ADDENDUM NO.1

RFP 18-788 Fabrication and Installation of Signs for Parking Pilot Program

VILLAGE OF OAK PARK
123 MADISON STREET
OAK PARK, IL 60302

Daytime Parking Restrictions

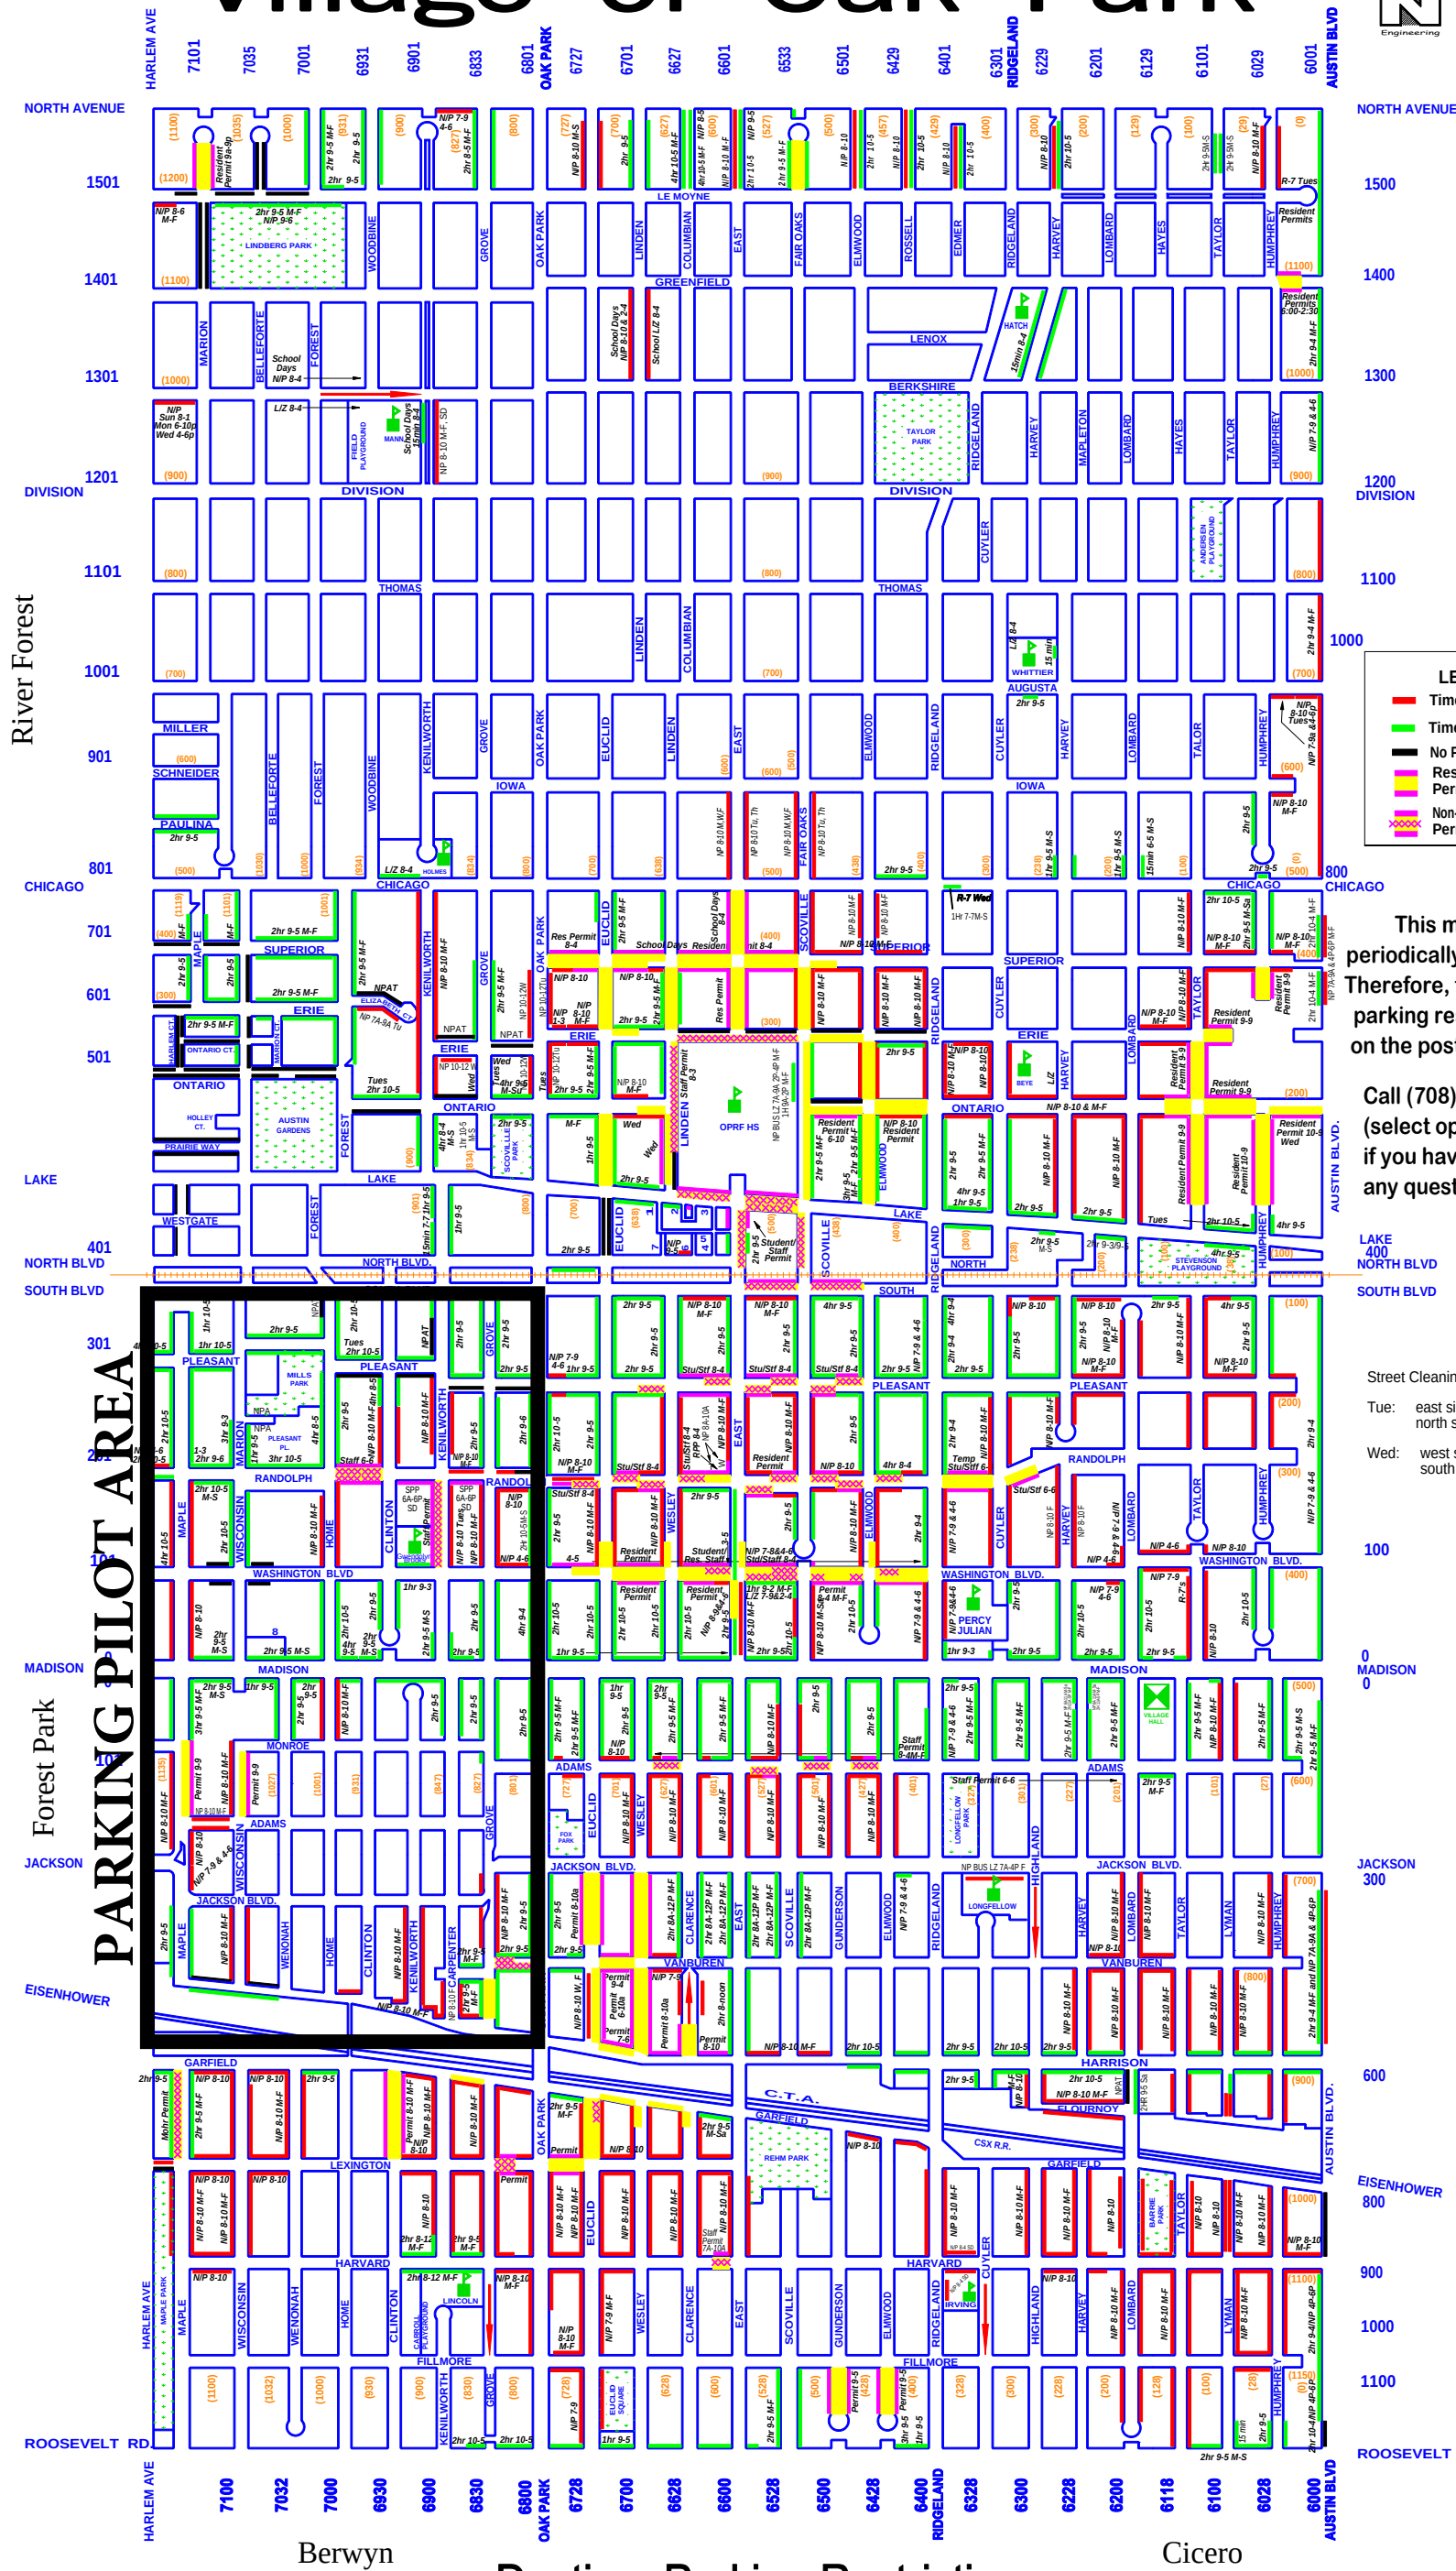
- Diamond Grade Cubed sheeting
- 6) Do you have a map?
 - See attached map and outlined "Parking Pilot Area". This map shows curbs with daytime restrictions, which will all be standardize with this project to 3-hour parking Monday-Friday. All curbs noted to have daytime restrictions will thus have signage updated to reflect the new restriction.
